To: Natural Resources Wales
From: Jen McMillan
Date: 25 February 2020
Copy: James Orme, Graham Morley
Our reference: PB5034-RHD-ZZ-XX-NT-Z-1000
Classification: Project related

Subject: Updated assessments for terrestrial ecology (excluding chough) in response to comments made on the Environmental Statement by NRW and RSPB: draft for discussion in meeting schedules 28/2/2020

Drawing title:

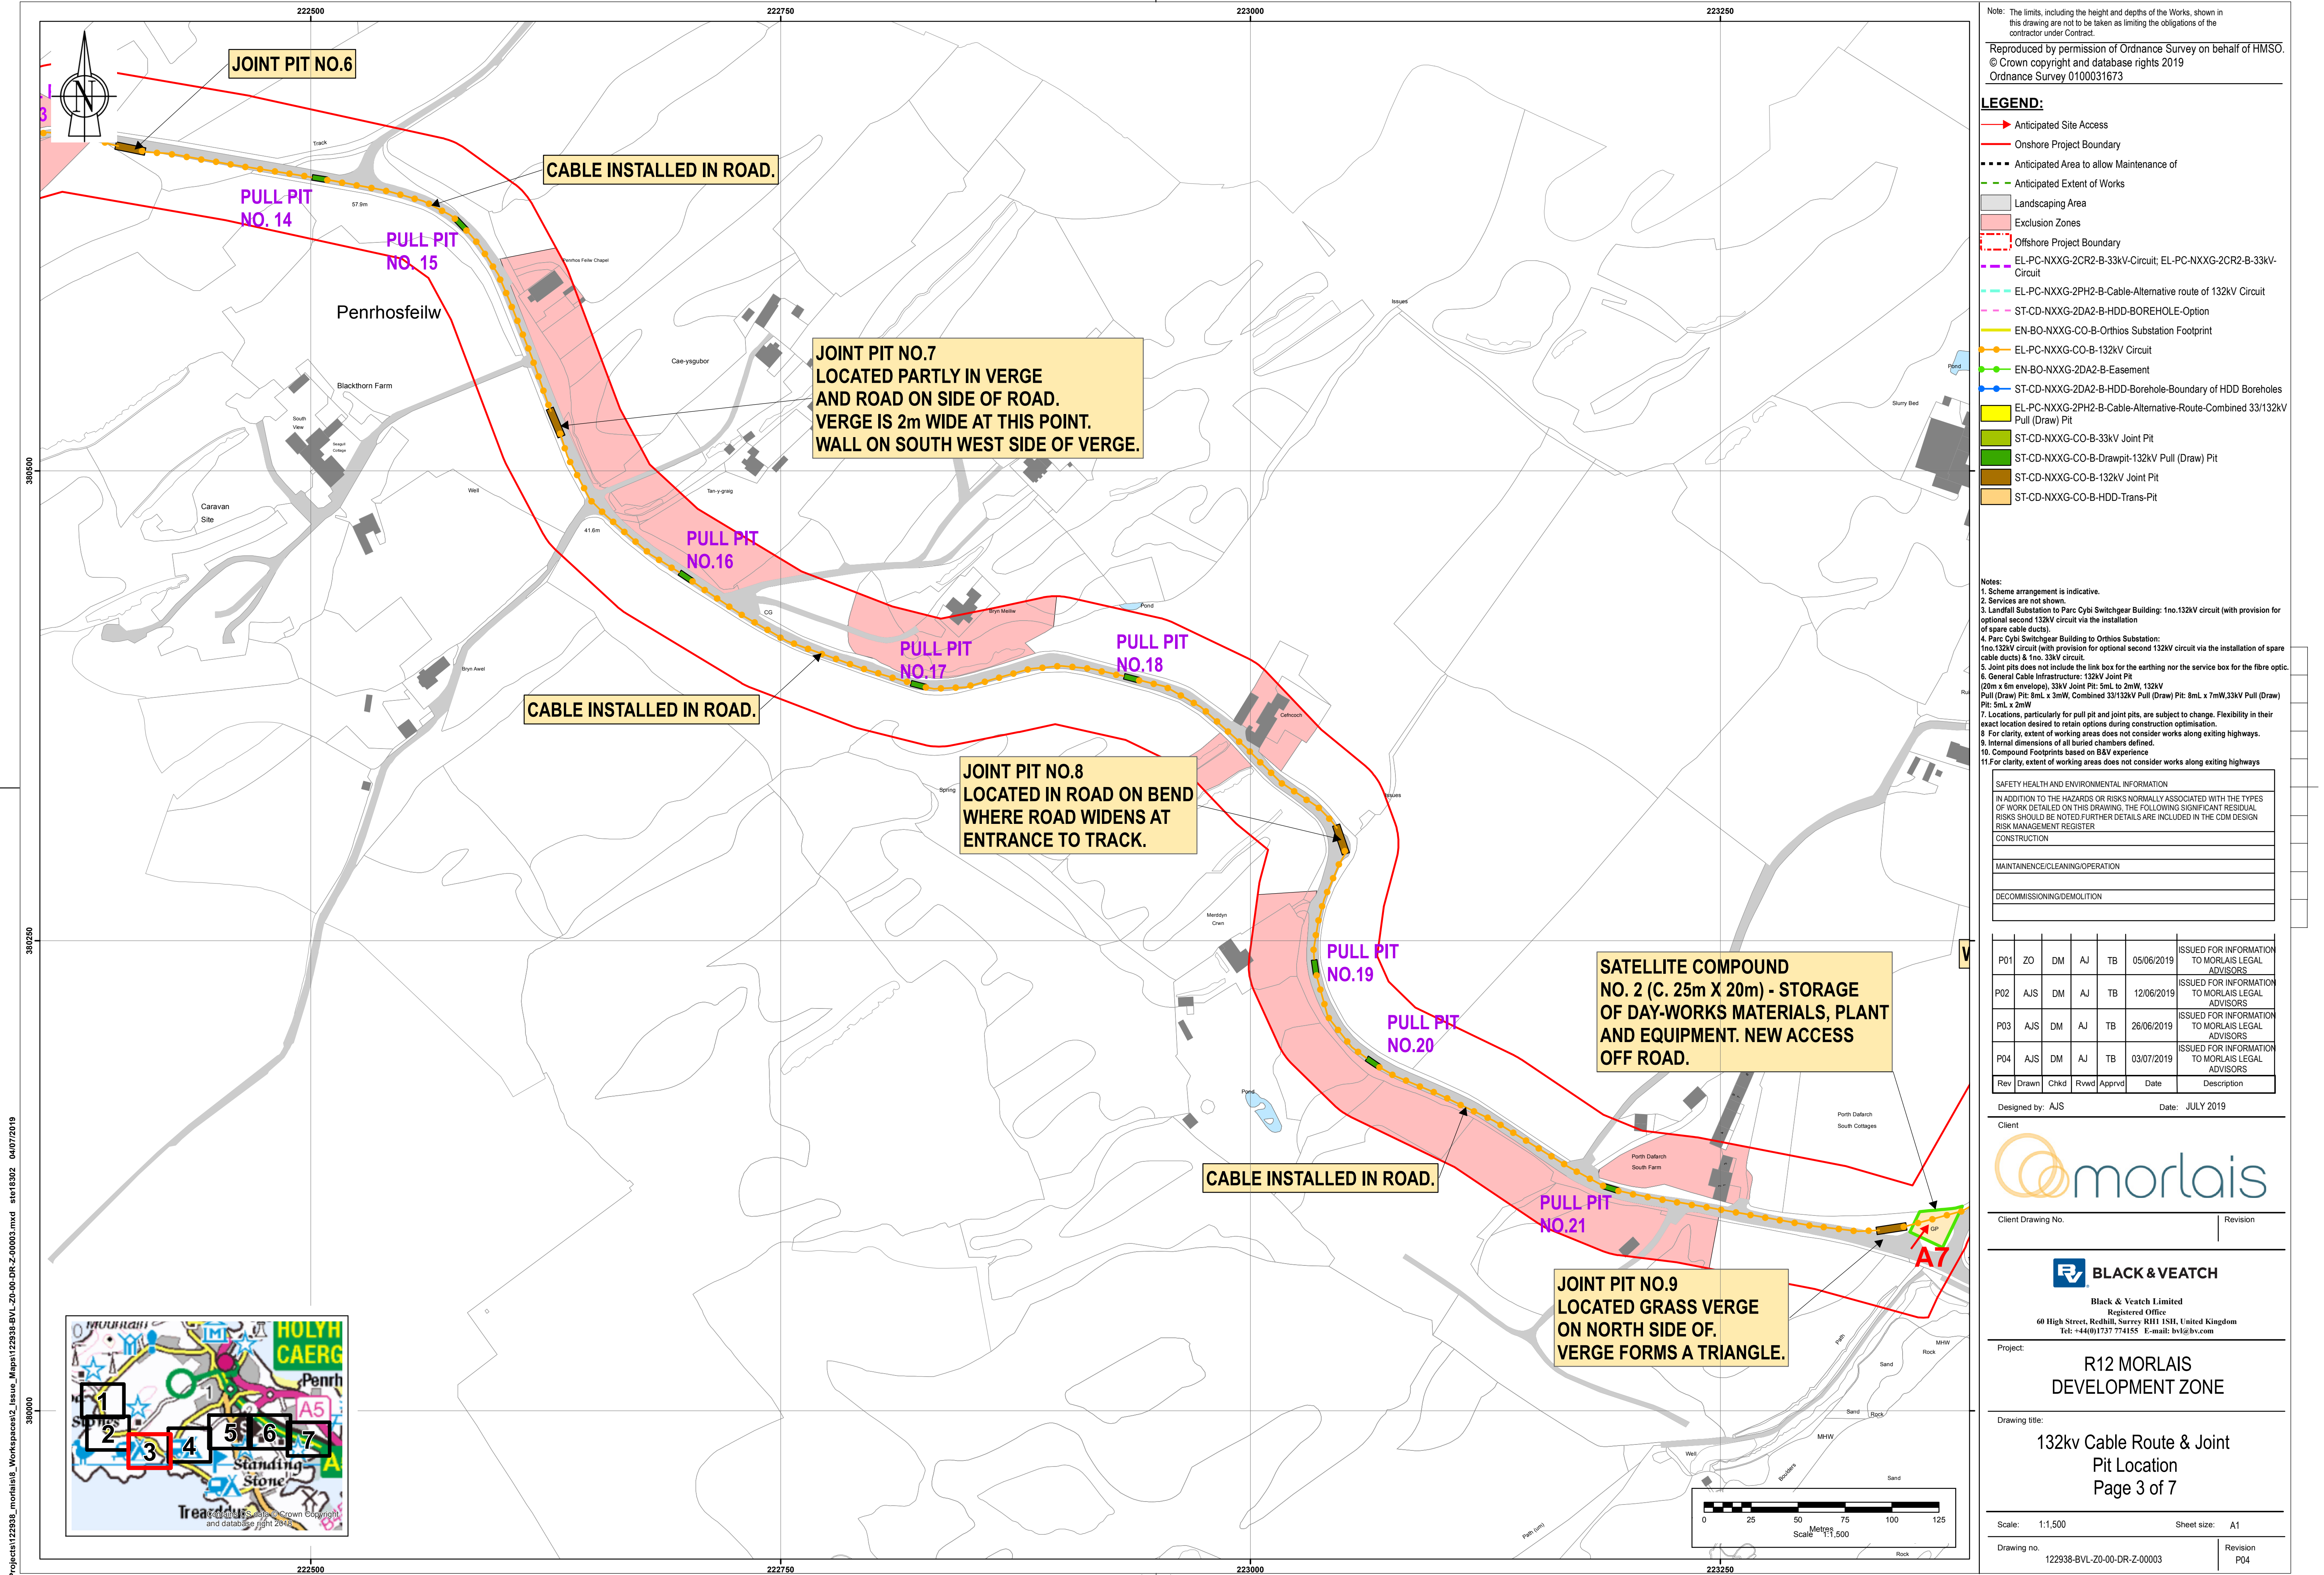
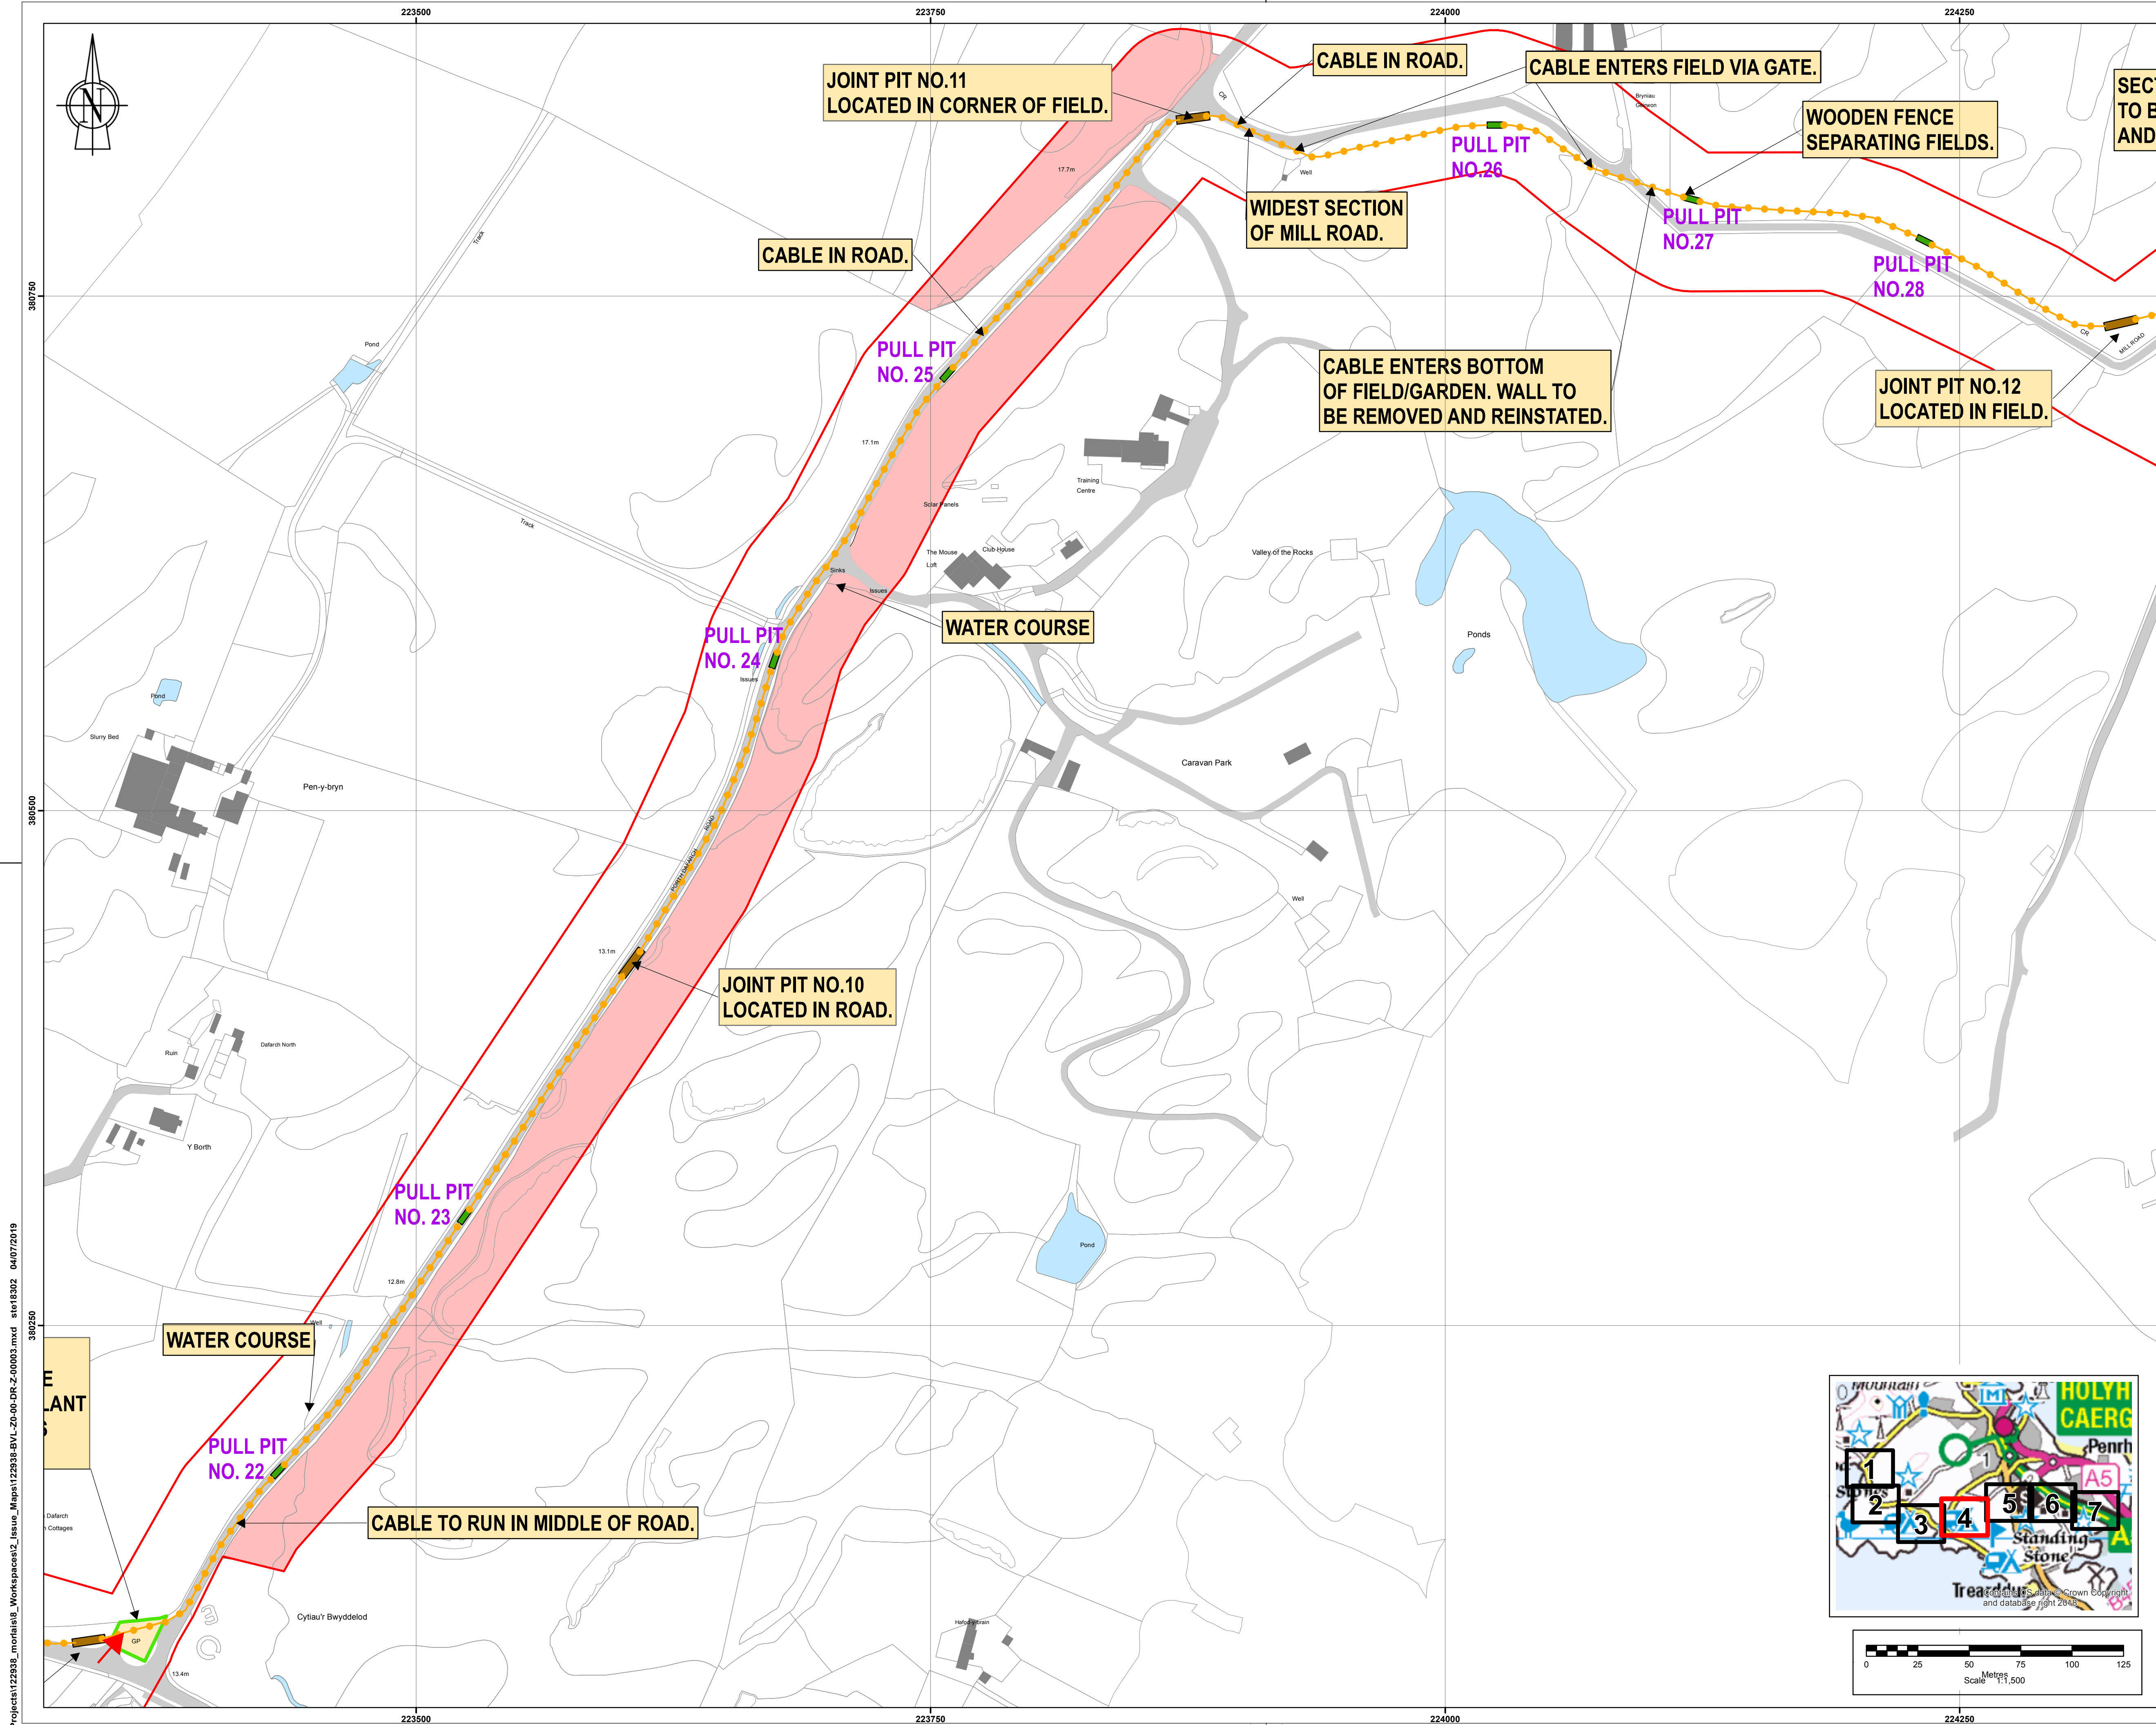
27	Paragraph 997: It should be stated here that not only will materials and equipment be stored within the construction footprint, but they will be stored outside the designated site boundary.	Methodology updated in Section 5 of this document to include for no storage in the designated site boundary
28	We advise that further work to reduce the impact on hedgerow and cloddiau due to their removal is made - possibly using HDD at these locations. NRW would expect that if the removal of any hedgerow or cloddiau cannot be avoided, a licenced ecologist or Environmental Clerk of Works (ECow) should be on site to provide the necessary expertise. The qualifications, licencing and contact details for this person should be forwarded to NRW as early as possible. NRW would expect this person to be the main point of contact for all ecological matters during this work.	Mitigation updated in Section 7.1 of this document to use trenchless crossings for cloddiau and any sensitive hedgerows

This section should be read alongside Drawing 2: 122938-BVL-Z0-00-DR-Z-00003.

Two out of the proposed nine draw-pits will be located within the unimproved neutral grassland, the other seven being located within the poor semi-improved grassland. It is proposed to leave all nine manhole covers in place, to reduce temporary disturbance to the habitat during planned or unplanned maintenance events. The footprint of the manhole covers, and the nine ground anchors will result in permanent habitat loss as presented in Table 6.2.. There will be no laydown areas for plant or equipment within the neutral grassland habitat, recognising that this habitat is considered to be of high sensitivity.

In response to consultation undertaken with NRW, who raised concerns regarding the impacts associated with the removable and re-construction of cloddiau, trenchless methods will be now employed to cross under cloddiau to avoid direct impact to these features. Consequently, there will be **negligible** impact upon the cloddiau features.
